REV. C

SAE AS9696

BOLT, MACHINE - DOUBLE HEXAGON EXTENDED WASHER HEAD, PD SHANK, CORROSION AND HEAT RESISTANT STEEL, UNS N07001, 165 KSI MIN, .1900-32 UNJF-3A

ISSUED 1999-08 REVISED 2010-08

FIGURE 1 - BOLT

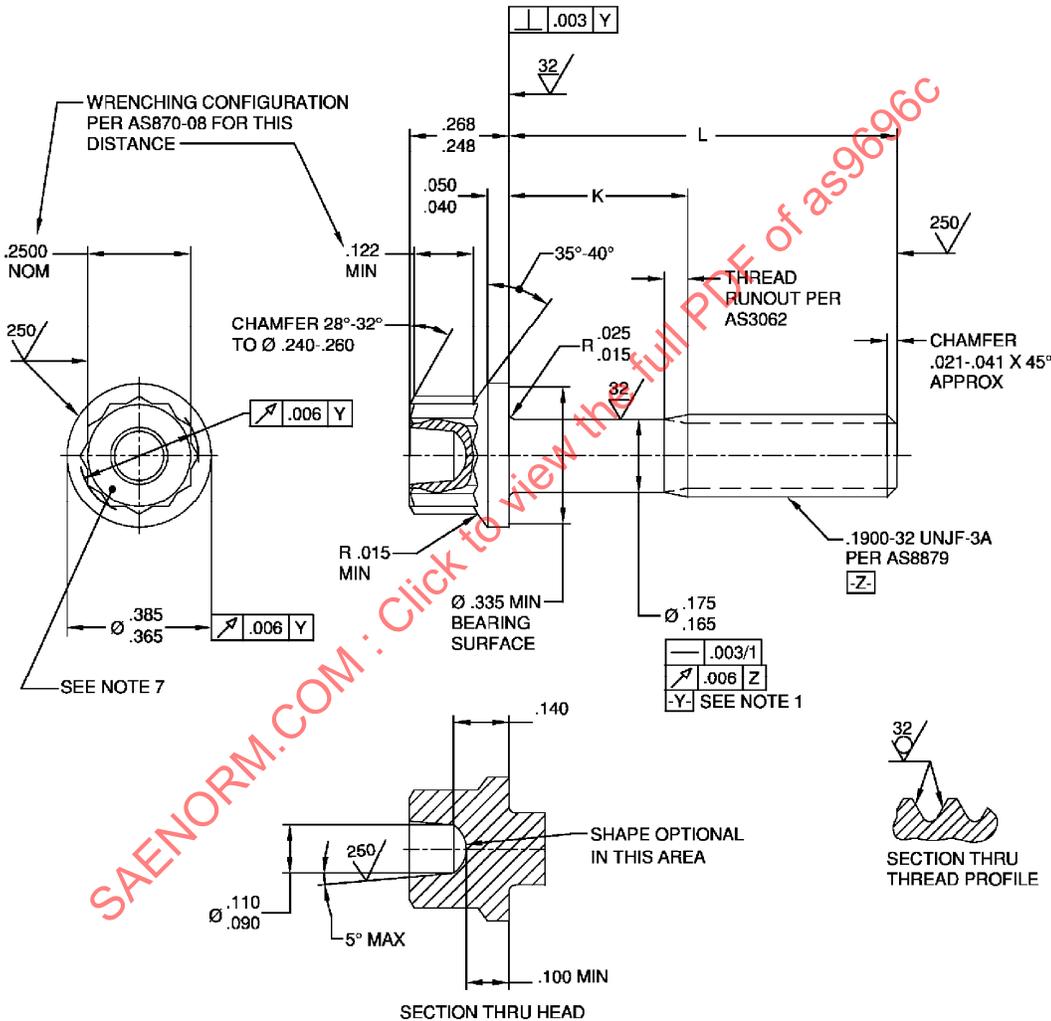
REDRAWN TO PROVIDE ALTERNATIVE METHOD OF MANUFACTURE OF THE LIGHTENING HOLE.

CLARIFICATION OF NOTE 5 ON FILLET ROLL REQUIREMENTS FOR SHORT LENGTHS.
